**SUMMARY OF CHANGES  
ITS SECTION 3.9**

**CNP UNITS 1 AND 2  
IMPROVED TECHNICAL  
SPECIFICATIONS CONVERSION**

**ITS SECTION 3.9  
REFUELING OPERATIONS**

**Revision 1**

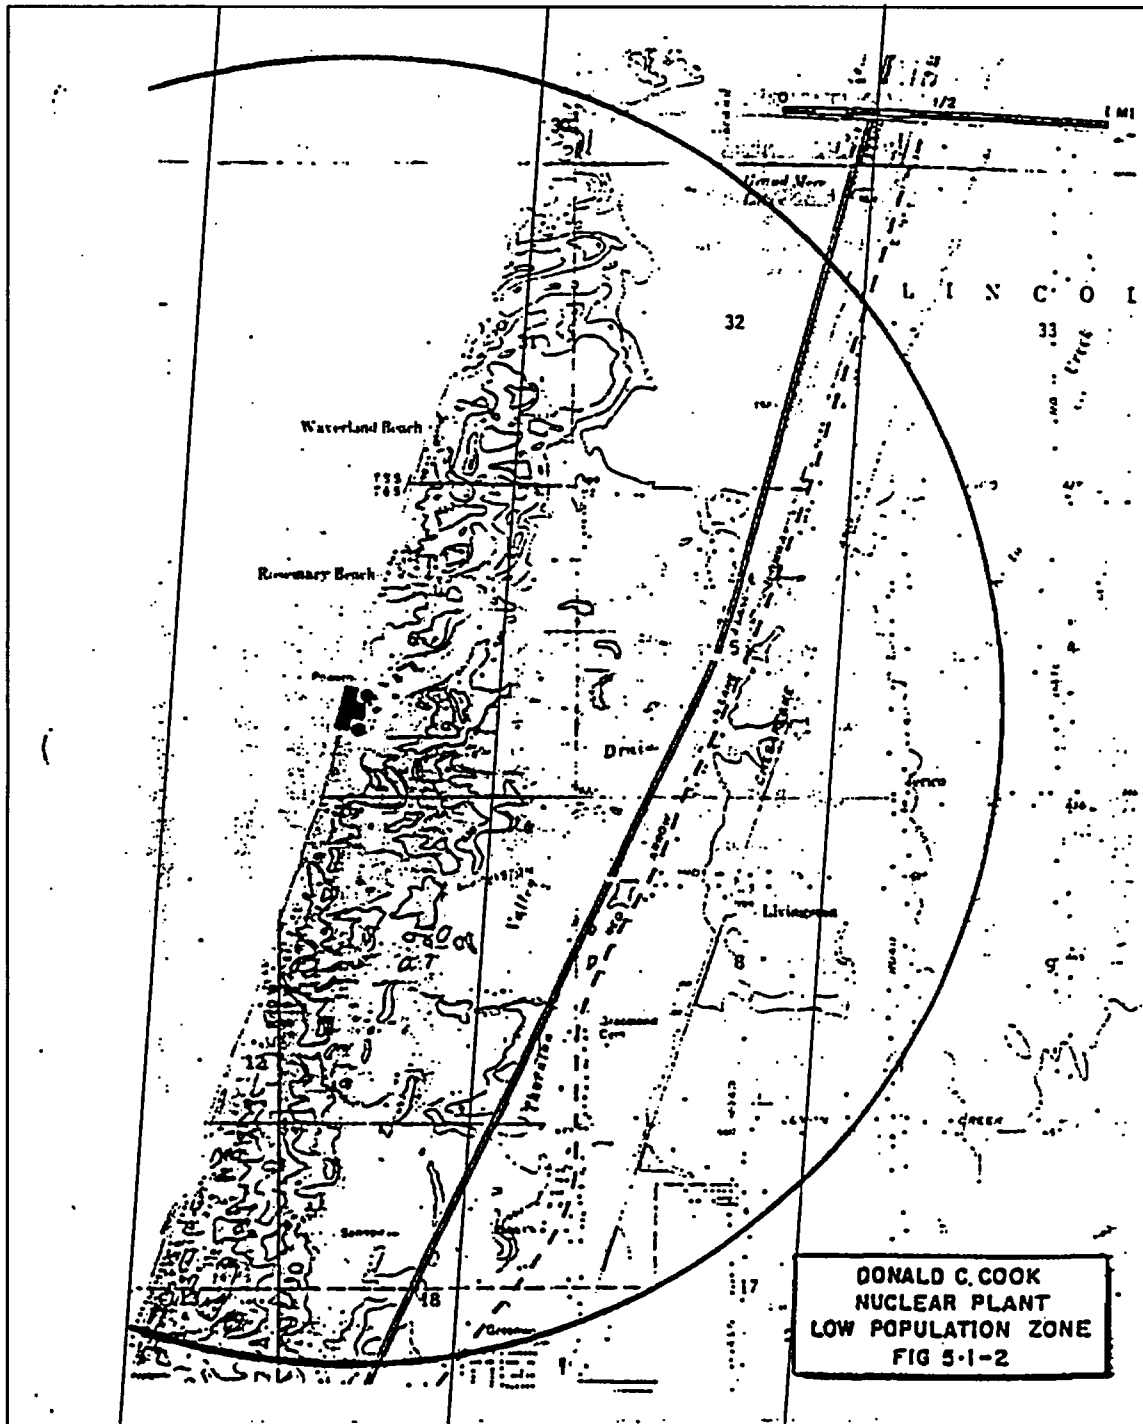
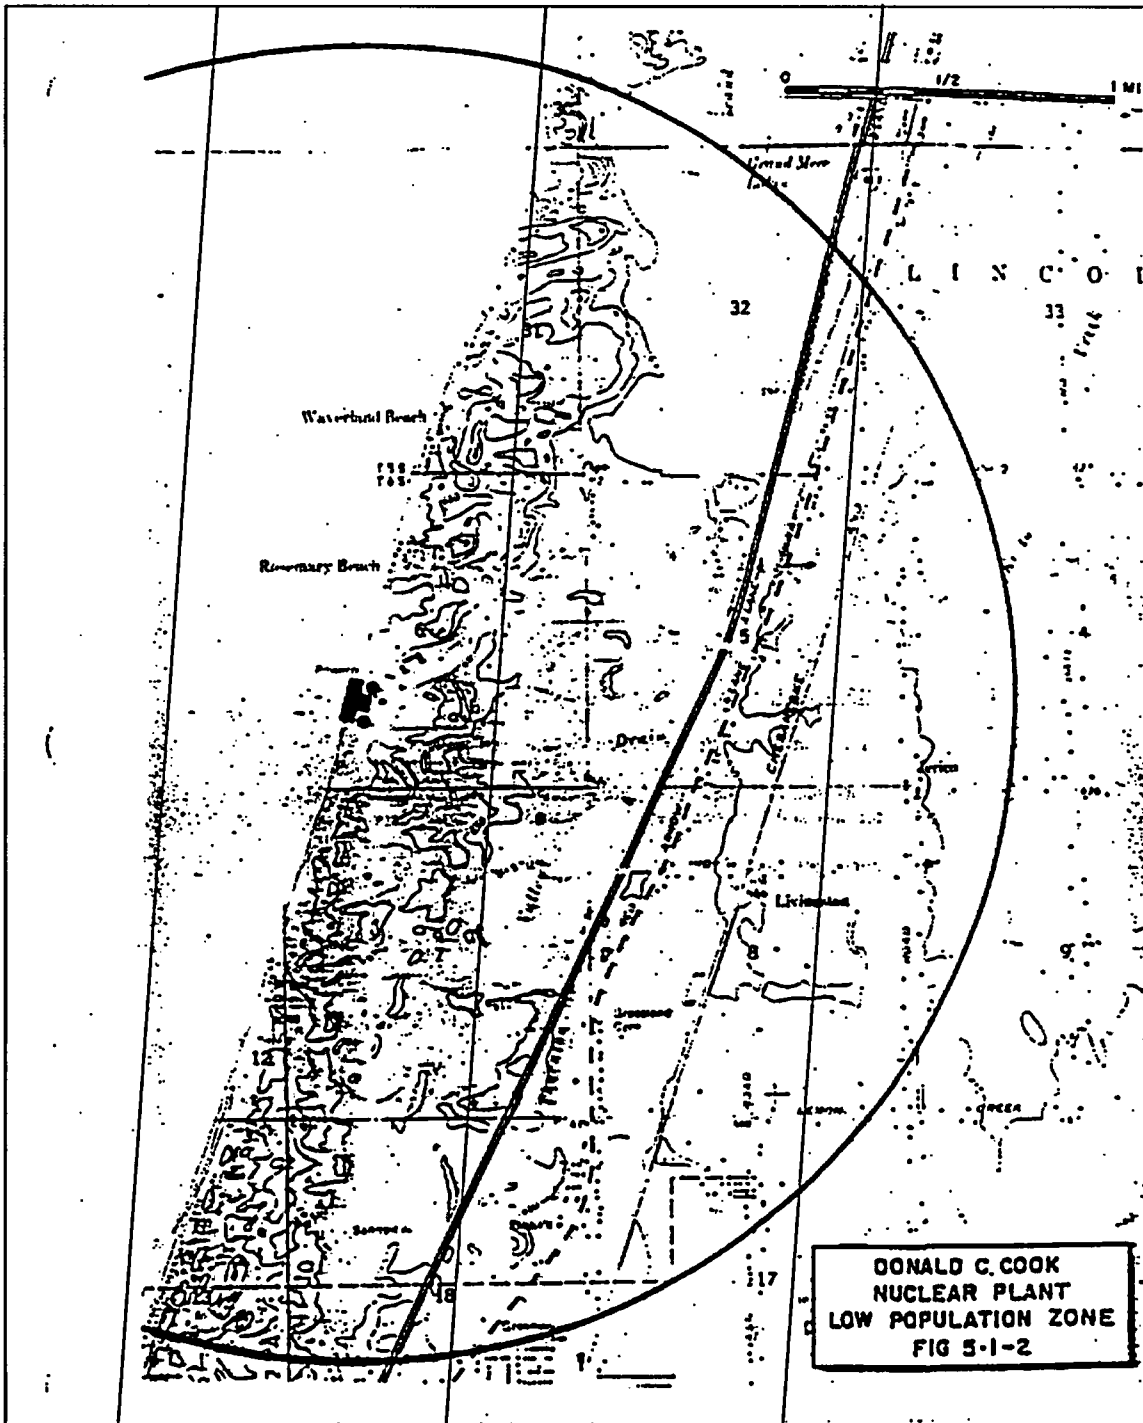
- A.2 CTS 5.1.2 states "The low population zone shall be as shown in Figure 5.1-2." CTS Figure 5.1-2 provides a map depicting the low population zone. ITS 4.1.2 provides a description of the low population zone; a figure is not provided. This changes the CTS by providing a word description of the low population zone instead of a map.

FIGURE 3.6-1: Normal Storage Pattern (Mixed Three Zone)

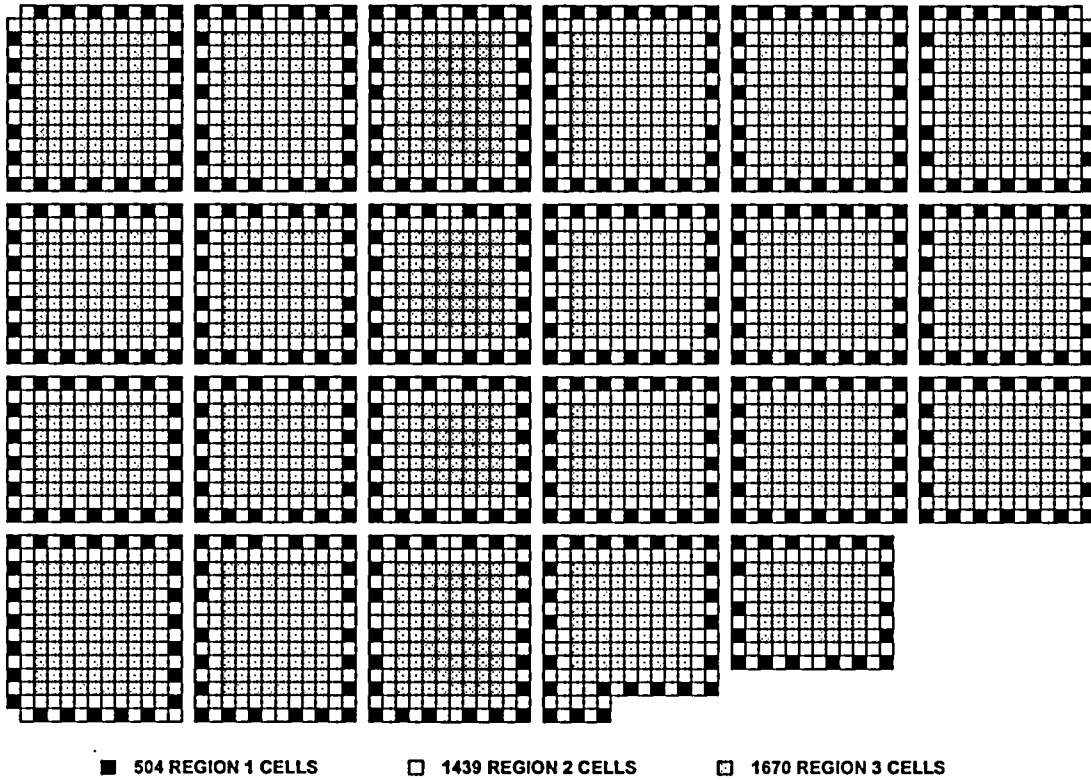
- A.3 CTS Figures 5.6-1 and 5.6-2 provide drawings that depict the various regions of the spent fuel storage pool racks for a normal storage pattern (mixed three zone) and for an interim storage pattern (checkerboard). The key at the bottom of the figures identifies the total number of cells for the various regions. The CTS Figure 5.6-1 key identifies, in part, that there are 1415 Region 2 cells and 1694 Region 3 cells, and the CTS Figure 5.6-2 key identifies, in part, that there are 1415 Region 2 cells and 1379 Region 3 cells. The ITS Figure 4.3-1 key identifies that there are 1439 Region 2 cells and 1670 Region 3 cells, and the ITS Figure 4.3-2 key identifies that there are 1439 Region 2 cells and 1355 Region 3 cells. This changes the keys to clearly identify the actual number of cells depicted in each region.

Figure 4.3-1 (Page 1 of 1)  
Normal Storage Pattern (Mixed Three Zone)
